Certificate of Appropriateness

Property	2617 N. Wahl Ave. North Point North HD
Description of work	Project includes repairs to the roof, soffits, and masonry. The north parapet masonry wall and stone cap will be repointed. The front chimney will be tuck pointed and the area of the roof surrounding the chimney will be repaired. Front and rear gutters will be replaced. See attached approved descriptions of work from the Wisconsin State Historical Society.
Date issued	10/16/2019 PTS ID 114876 COA roof, masonry, and related repairs

Present condition of the north parapet wall

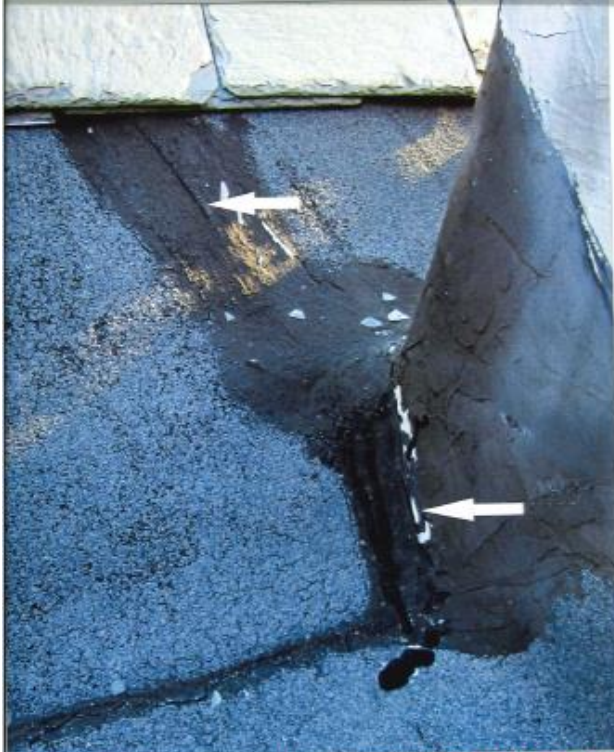
Caulk and mortar joints failing and flashing coming loose

Images of north parapet wall and eave, north facing side. Mortar joints failing, bricks will be checked for integrity, mortar joints between the masonry and along the limestone cap will be tuck pointed.

New mortar must match the original mortar in terms of color, texture, grain size, joint width, and joint finish/profile. The compressive strength of the repointing mortar shall be equal or less than the compressive strength of the original mortar and surrounding brick or stone. The replacement mortar shall contain approximately the same ingredient proportions of the original mortar. Mortar that is too hard is subject to premature failure and could damage the masonry. See the city's books As Good As New or Good for Business, Masonry Chapters, for more information. In most cases, this means a lime mortar with natural hydraulic cement rather than Portland cement. **No joint of a width less than 3/8" may be cleaned of damaged/decomposed mortar with power disc grinders. No over-cutting of the joints is permitted. Remove decomposed mortar back into the wall 2.5 times the height of the joint before repointing.**

Valleys must be metal W-shape with no interweaving of shingles. Valleys and flashing must be painted or factory-finished to match the roofing color, unless copper. When installing new flashing at a masonry feature (chimney, parapet wall), the flashing must be stepped or cut into the mortar joints. The bricks may not be cut to install flashing at an angle.

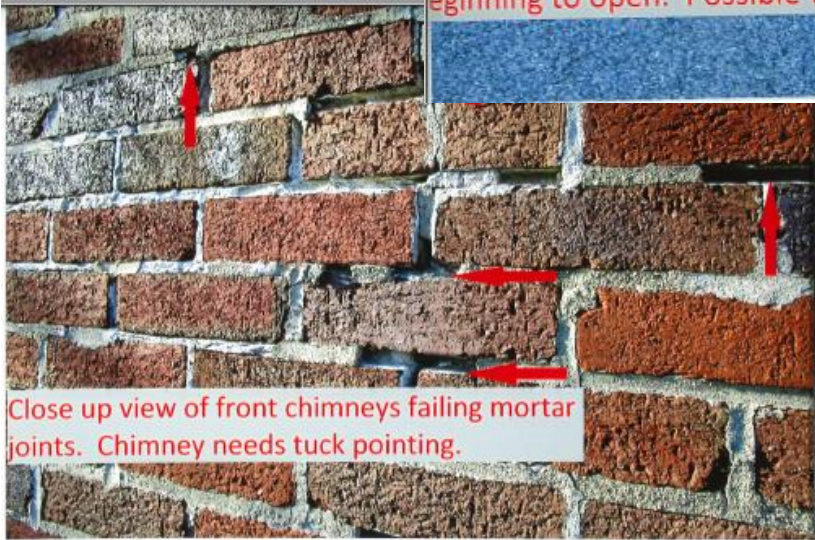
Chimney on the front of the home has large gaps in the mortar. In need of tuck pointing

At front chimney saddle corners of flat roof beginning to open. Possible water

Images of front chimney conditions. Mortar joints failing, will be ground out and tuck pointed. Roof flashing and slate repair surrounding the chimney, see attached description of work for details.
